Town of Kiawah Island Subdivision Request
Case #SBD24-000005 &
Case #SBD24-000006

Planning Commission Meeting: March 5, 2025

Application: A Subdivision Plat request to abandon an existing Right of Way and establish service vehicle access for the Cape Beach Club.

APPROVED FINAL PLAT

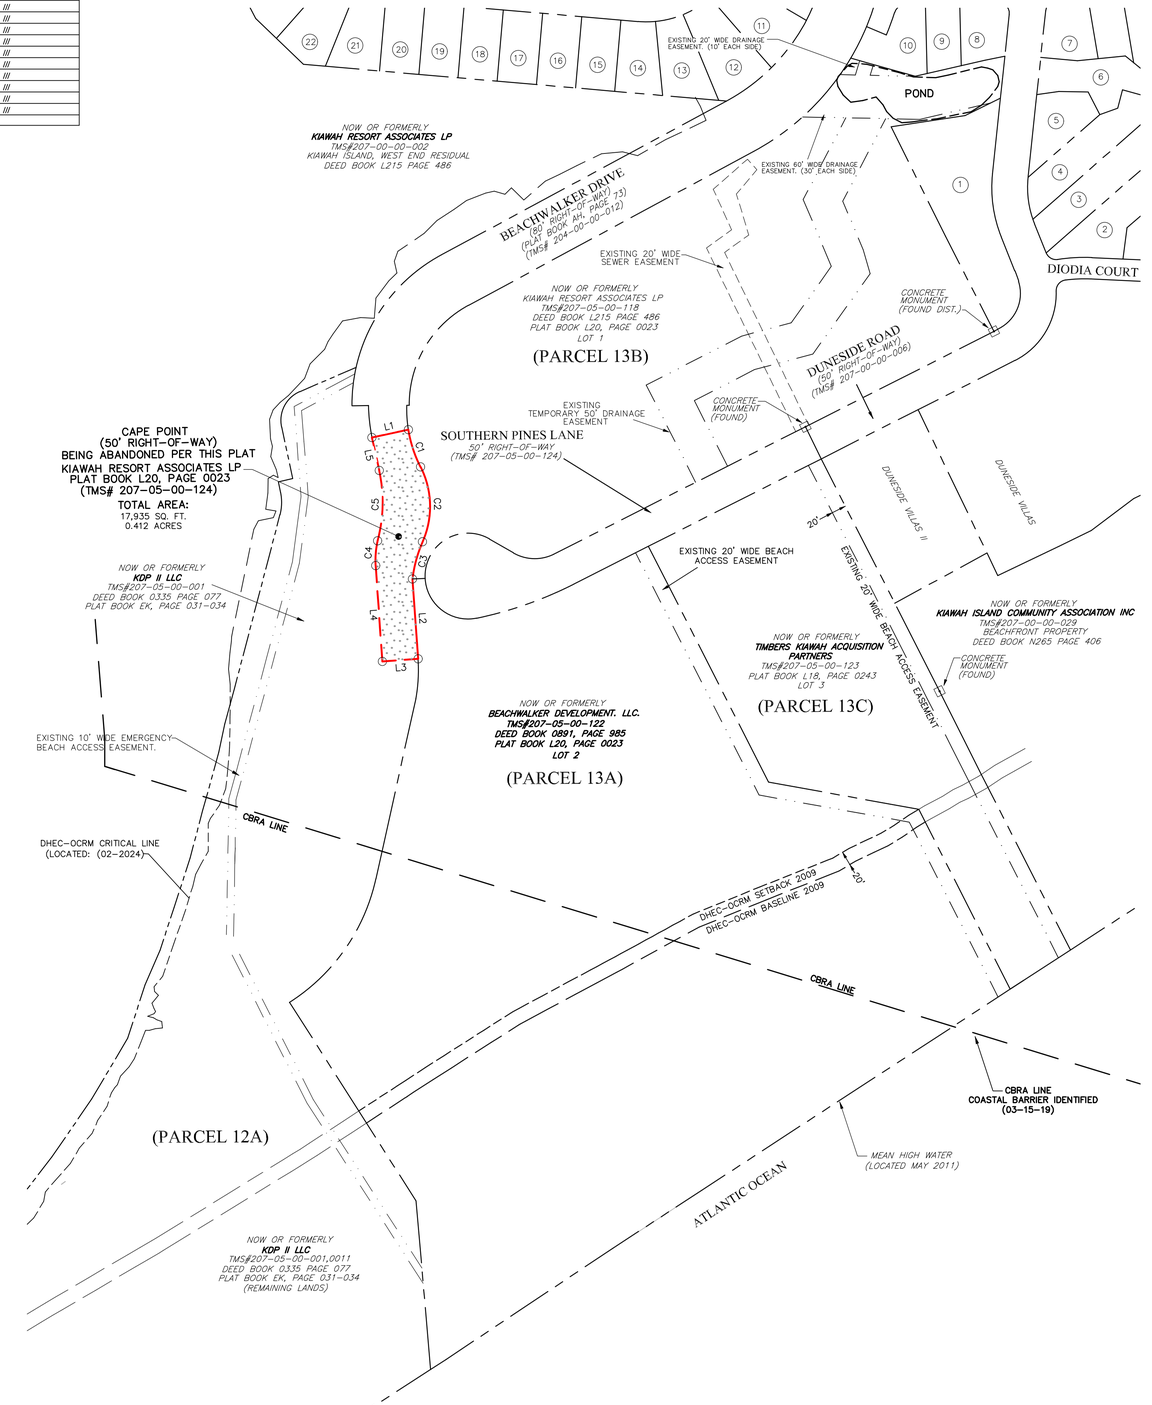
SBD24-000005 | The Planning Department has reviewed this document for FINAL APPROVAL of this subdivision to be known as An Abandonment Survey Plat of Cape Point Right-of-Way and finds that it is consistent with Chapter 12 Article III Subdivision Regulations.

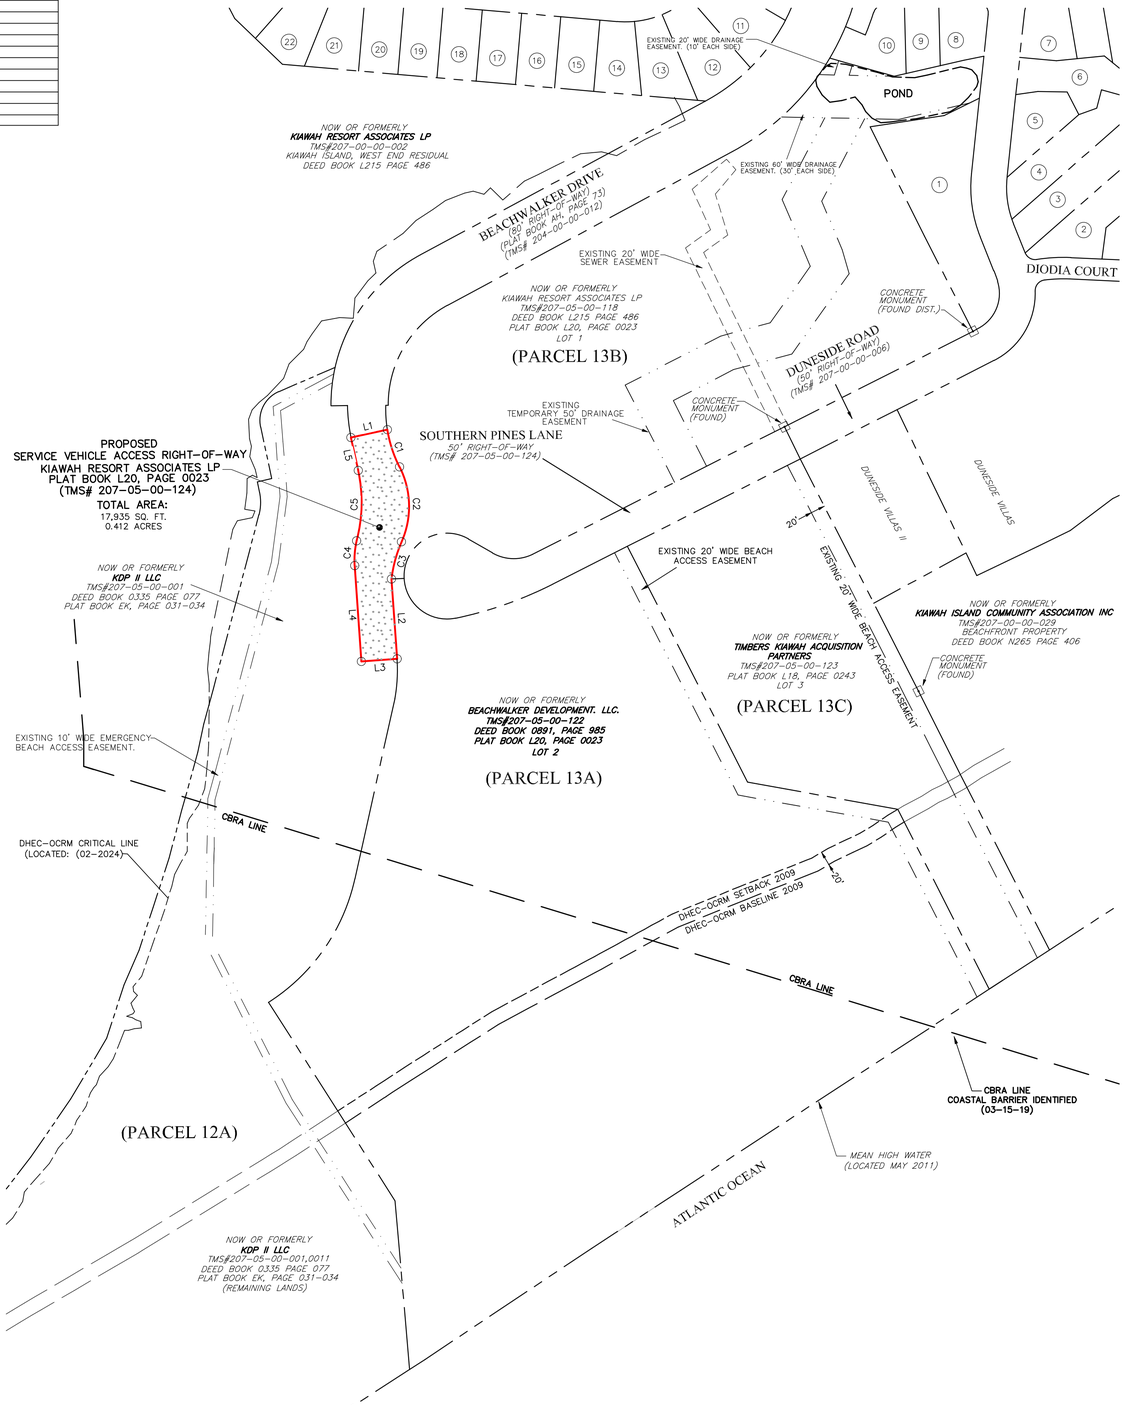
SBD24-000006 | The Planning Department has reviewed this document for FINAL APPROVAL of this subdivision to be known as A Final Plat of Service Vehicle Access Right of Way and finds that without a waiver pursuant to Sec. 12-254. it is inconsistent with Chapter 12 Article III Subdivision Regulations.

Should the Planning Commission consider approval of Case #SBD24-000006, Planning Director recommends granting approval of the requested waiver and that the Planning Commission consider the following conditions:

1) The applicant shall add to the plat the following note: "The subject parcel (TMS#207-05-00-124) shall not be used as vehicular access to Parcel 12B (Captain Sams Spit) as described in the previously executed 2013 Amended and Restated Development Agreement by and between Kiawah Resort Associates L.P. and the Town of Kiawah Island."

2) The applicant shall add to the plat the following note: "The Service Vehicle Access shall have no vehicular access into the Cape Club expect for the smaller utility vehicles transporting items back and forth between the terminus and the Cape Club connecting across the property line to the Cape."

3) The applicant shall provide a copy of a recorded separate deed restriction or covenant on the new access parcel prohibiting its use for vehicular access to parcel 12B(Captain Sams Spit) as described
